CITY OF DELRAY BEACH
100 N.W. 1st AVENUE, DELRAY BEACH, FL 33444

Solicitation Addendum

Addendum No.: 2

Solicitation Title: Beach Master Plan, Phase 2 Construction

Bike Rack Detail

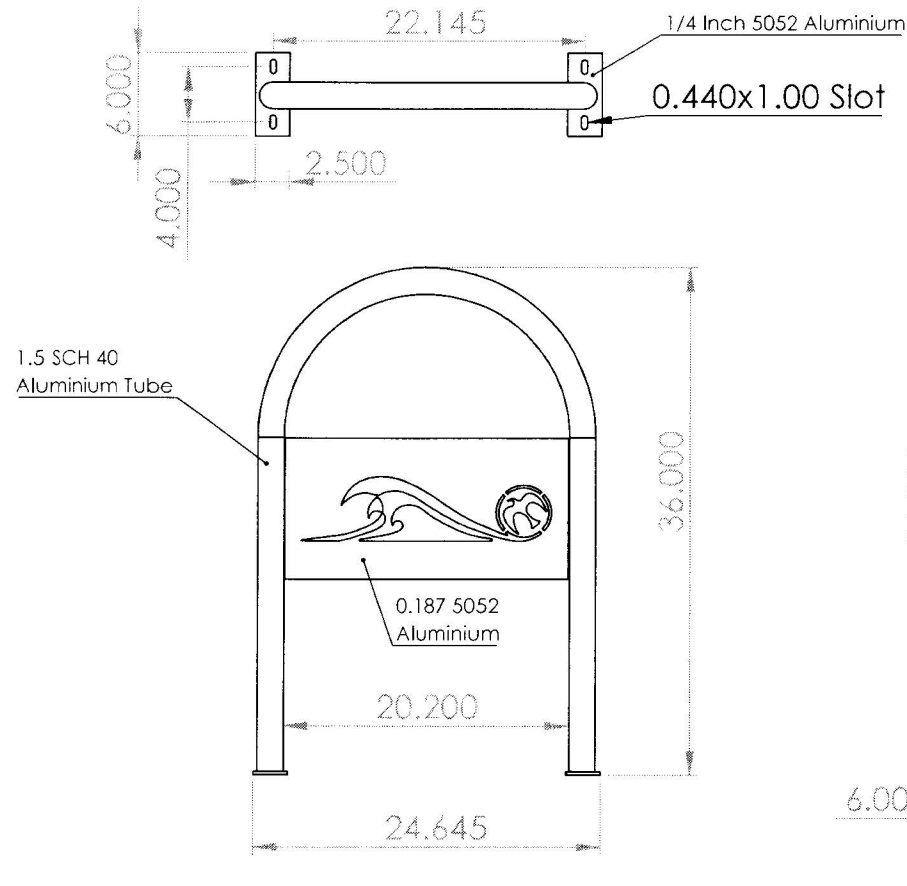
The attached document labeled “Bike Rack Detail” is hereby added to Exhibit A, Drawings.

Item Number:	<u>94</u>
Lot Name:	<u>On-Site Items – Base Bid</u>
Bid Item Title:	<u>Bike Racks</u>
Bid Item Description:	<u>Location to be coordinated with City upon contract award. Bike Racks are to be surface mounted with 3/16 stainless steel hardware with 3/16 stainless steel acorn caps. Inquiries sent to The Park Catalog 800-695-3503, reference Delray Beach Rack. Also, see cut sheet/specification added per Addendum No. 2.</u>
Quantity:	<u>25</u>
Unit of Measure:	<u>Each</u>
Shipping Location:	<u>Swinton Operations Complex</u>

Ameron™ Centrecon M-Series Round Pole - Embedded

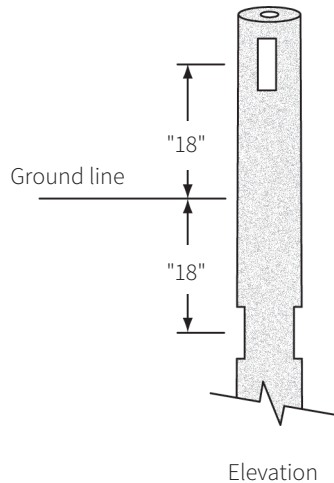
The attached document labeled "Ameron™ Centrecon M-Series Round Pole - Embedded" is hereby added to Exhibit B, Specifications.

SR135-L2W18K-2A-R2-120/277V-MST-APS
BLC2 WITH 270 DEGREE BEACHSIDE SHEILD
CONCRETE POLE BY AMERON
~~#MER04.3-12'-0"~~ MER03.2-10'-0" HEIGHT

SR135-L2W18K-2A-R2-120/277V-MST-APS
BLC2 WITH 270 DEGREE BEACHSIDE SHEILD
CONCRETE POLE BY AMERON
~~#MER04.3-12'-0"~~ MER03.2-10'-0" HEIGHT – WITH RECEPTACLE AT BASE

CONCRETE LIGHT POLE – AMERON ~~#MER04.3~~ MER03.2 – Bid No. 59

CONCRETE LIGHT POLE WITH RECEPTACLE AT BASE – AMERON
~~#MER04.3~~ MER03.2 – Bid No. 60
